PARTS & SERVICE	REF NO.	AT01125
NEWS	DATE	Aug. 29, 2001
		Page 1 of 4

SUBJECT: REPAIR OF STEERING CIRCUIT BLOCK ON WA1200-3

- **PURPOSE:** To introduce modification procedures to strengthen the steering circuit block on WA1200-3 wheel loaders
- APPLICATION: WA1200-3 Wheel Loaders, Serial Nos. 50001 thru 50010

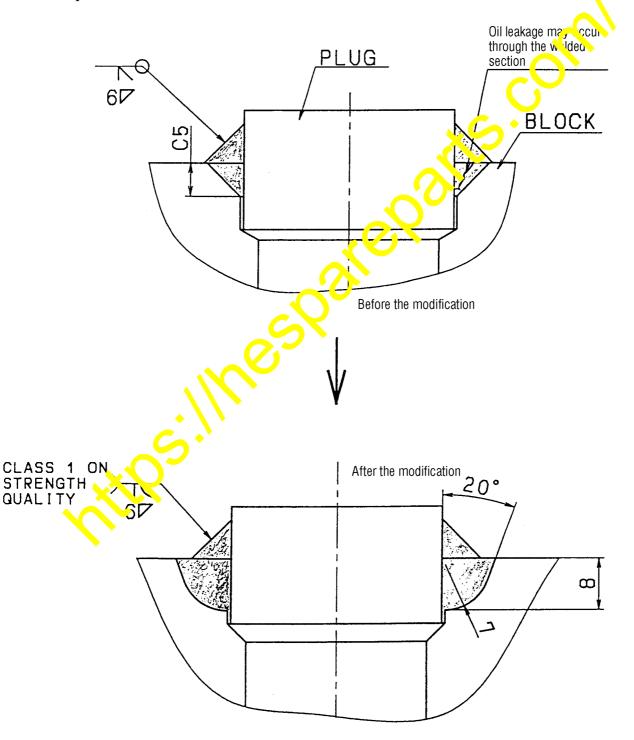
Cracks may occur in the inside structure of the welded section where a plug is welded, of the block contained in the steering circuit on the WA1200-3 wheel loaders because of dispersions of the fusing state of the plug, resulting in oil leading failure.

When the aforesaid failure is found to be occurring or when preventing occurrence of such failure, make the modification introduced in this Service News to replace the part with the improved part with stronger welding.

- 3. Contents of the modification
 - (1) The welding groove shape of the section where the plug is being welded has been changed and the welding quality has been upgraded. (To cope with the imperfect fusing problem)
 - Shape of the welding groove: "V" shape \rightarrow "J" shape
 - Welding quality:

Class 3 (Without designation in the drawing) \rightarrow Class 1 (Fusing: $\triangle 2 \text{ mm} \rightarrow +0.5 \text{ mm}$)

(2) The depth of the welding groove has been changed. 5 mm \rightarrow 8 mm (The throat depth has been increased to reduce stresses.)

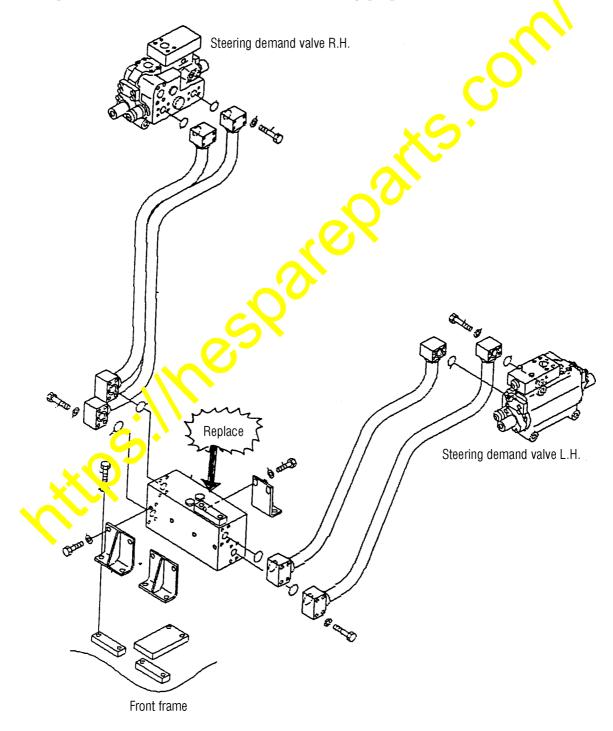
- 4. Replacing the parts for this modification
 - Precaution: For hazard preventing purposes, observe the instructions and designations of the Shop Manual (in the Section "Precautions when carrying out disassembly and assembly work" in the Chapter "Disassembly and Assembly") and the Operation and Maintenance Manual (in the Chapter "Inspection and Maintenance) when carrying out this replacement work.
 - (1) Replacing the block for the circuit connecting between the steering valve and the steering cylinder inside the front frame

Replace the block 42C-62-11181 with the newly prepared block 42C-62-11182.
